ADDENDUM NO. 03

August 14, 2026

Oak Hill United School Corporation – Multi-School MEP Improvements
405 South Washington St, Swayzee, IN 46986
7760 Delphi Pike, Converse, IN 46919
600 Walnut St, Converse, IN 46919

Addendum Three (AD.03) to the drawings and specifications prepared by Gibraltar Design for **Mechanical Improvements Across Three Schools** for Oak Hill United School Corporation Converse, Indiana.

A-410

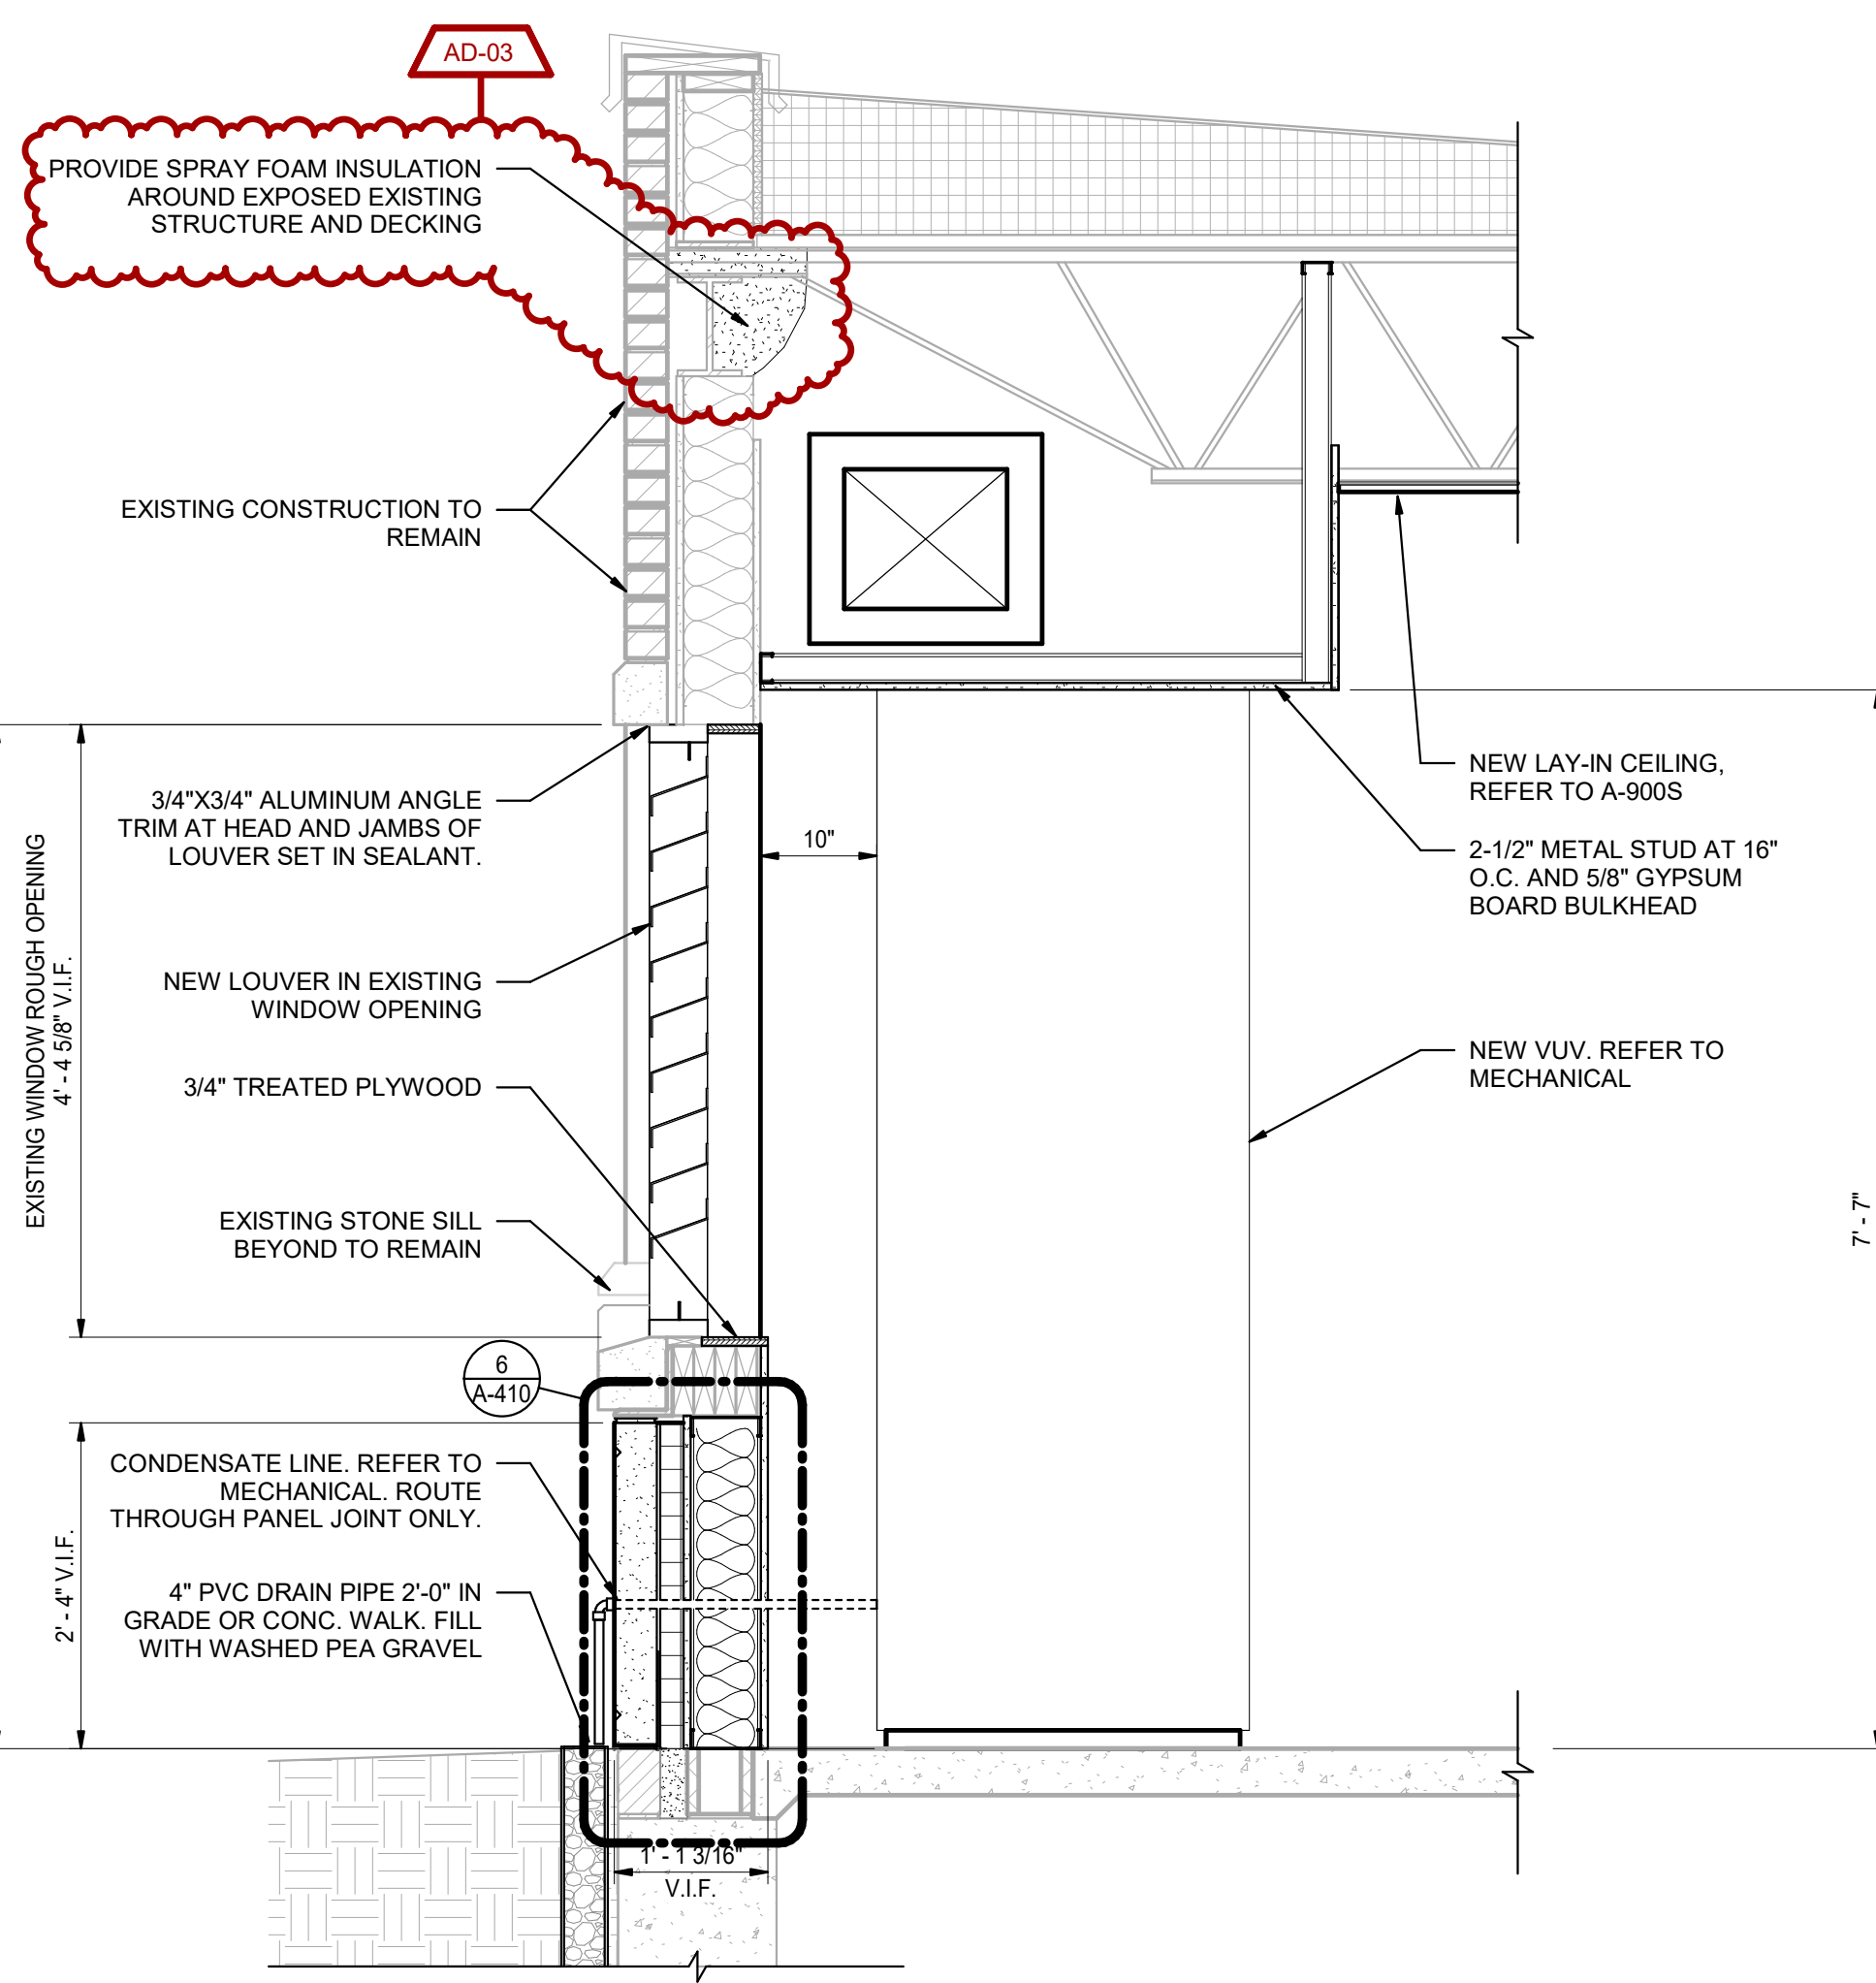
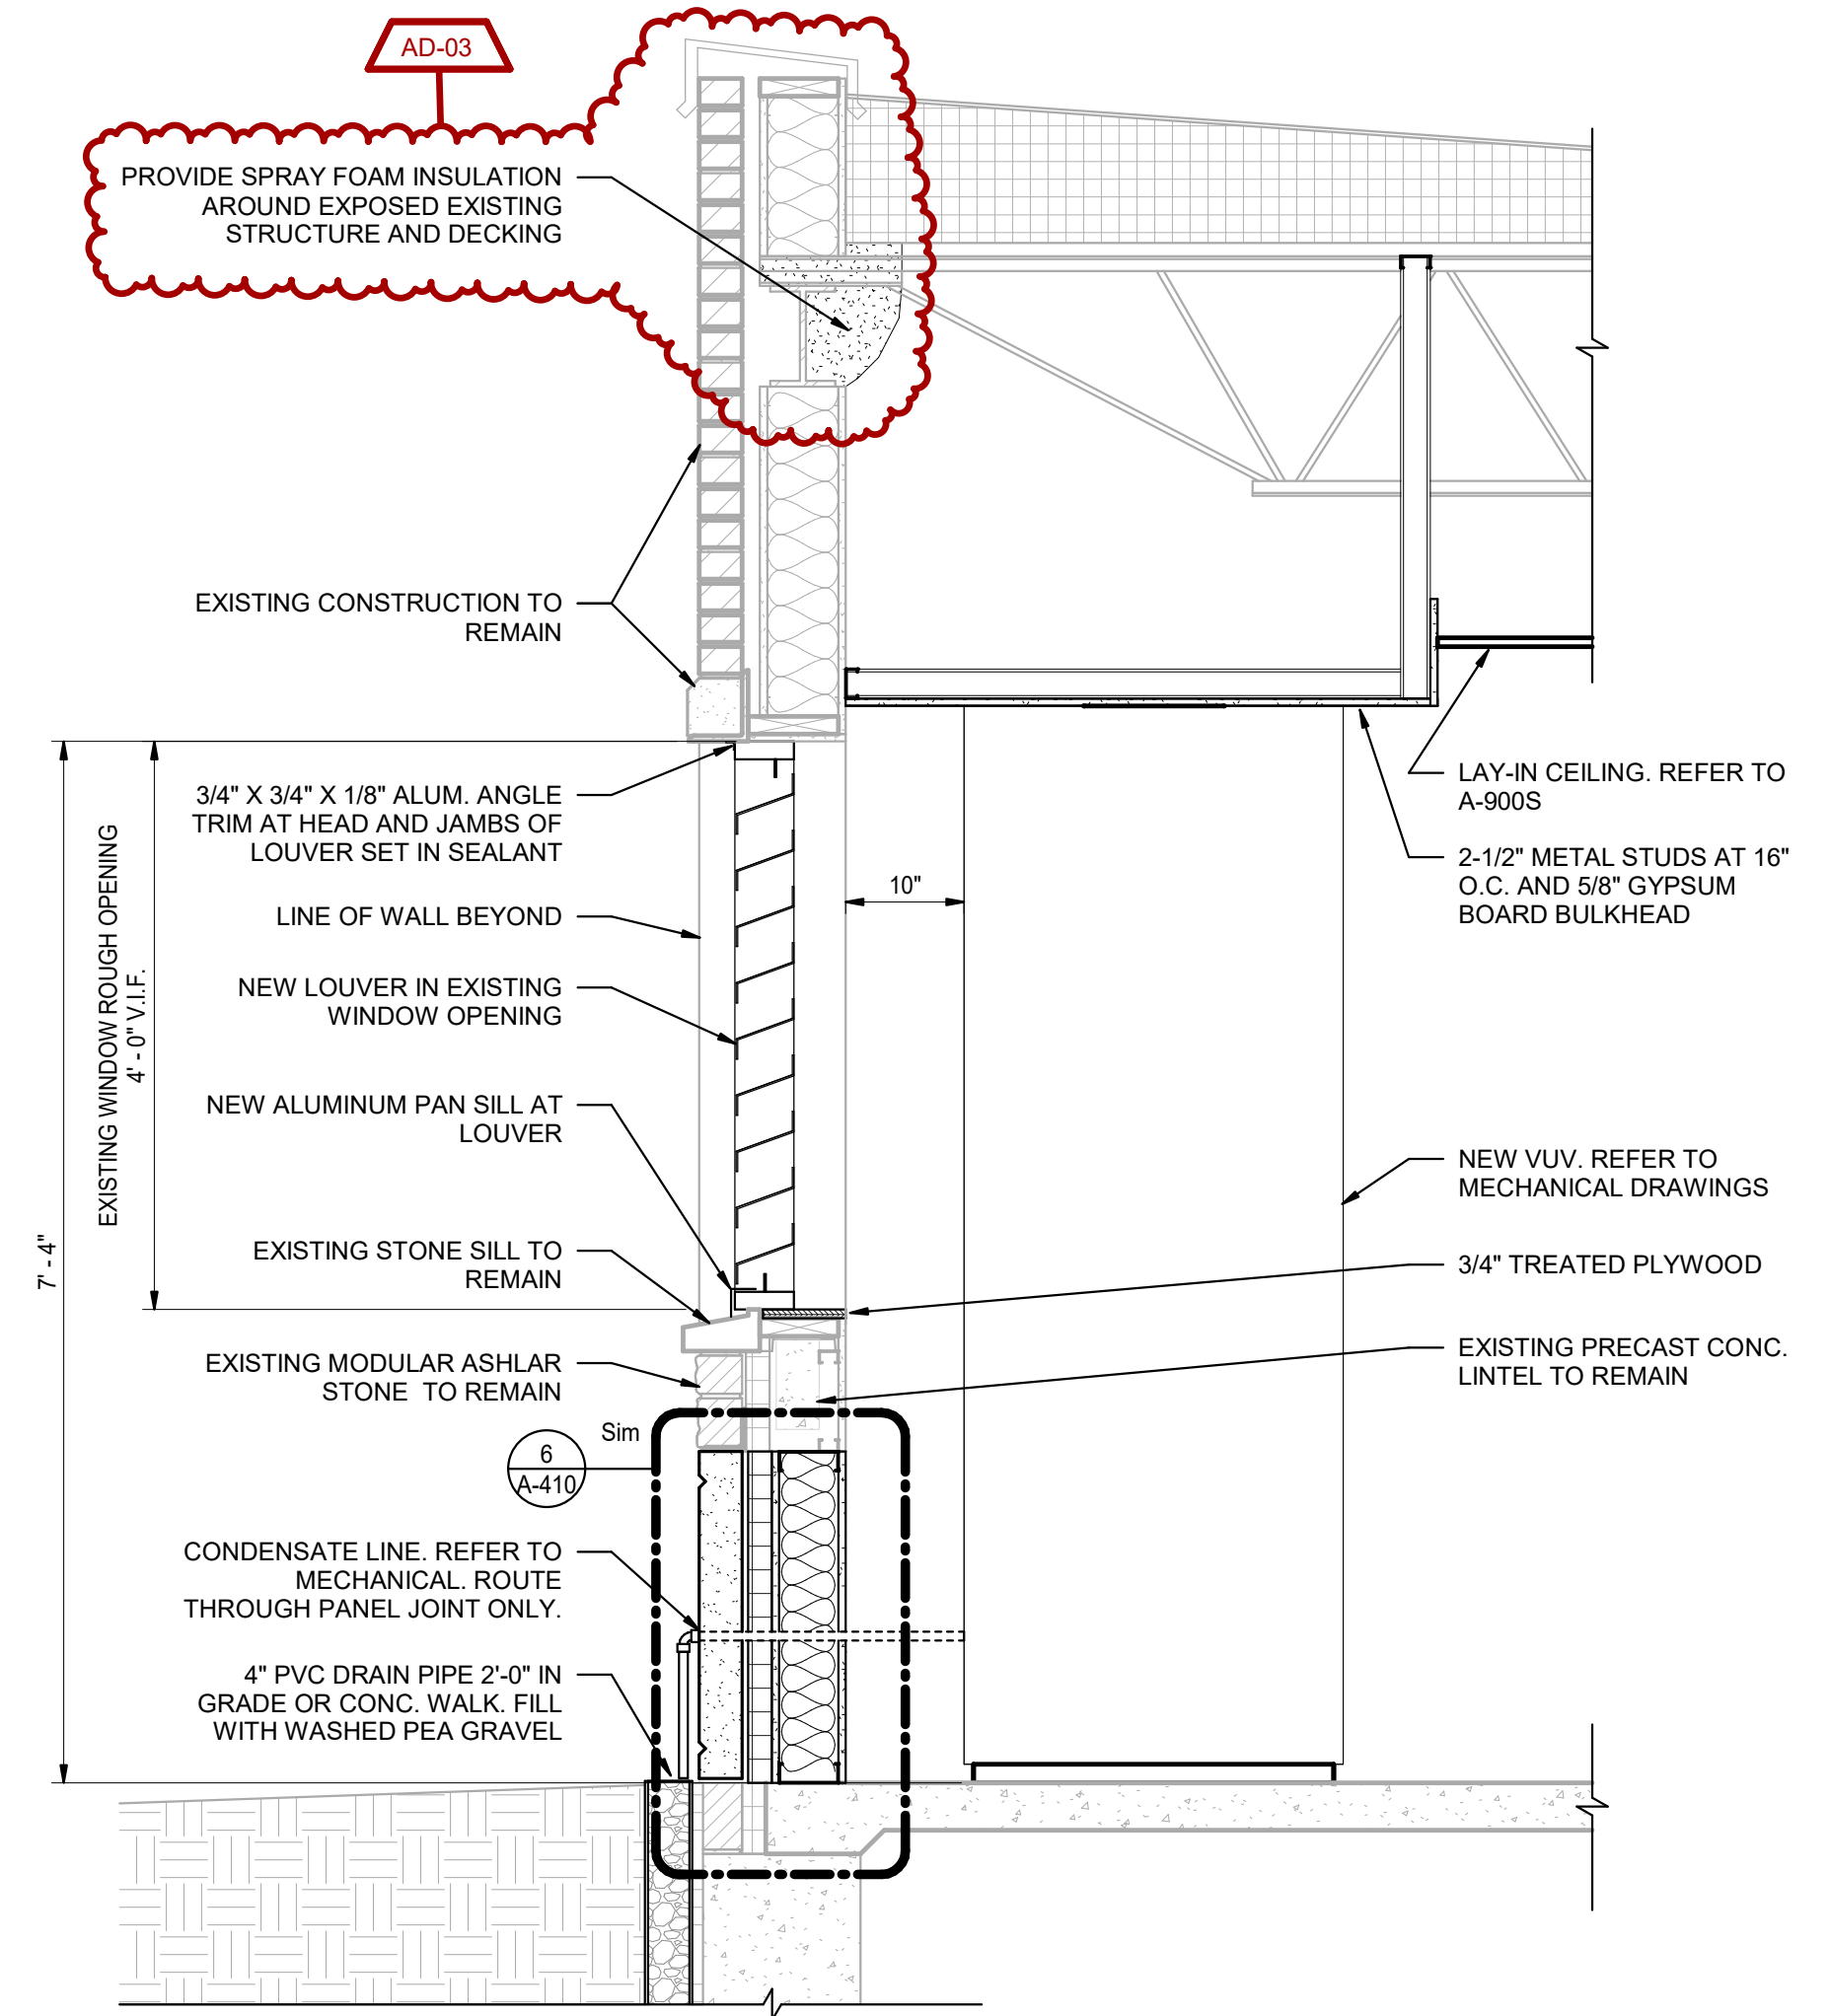
9. Sheet A-410

- A. Refer to revised, full-size drawings, included in this Addendum, for revisions.
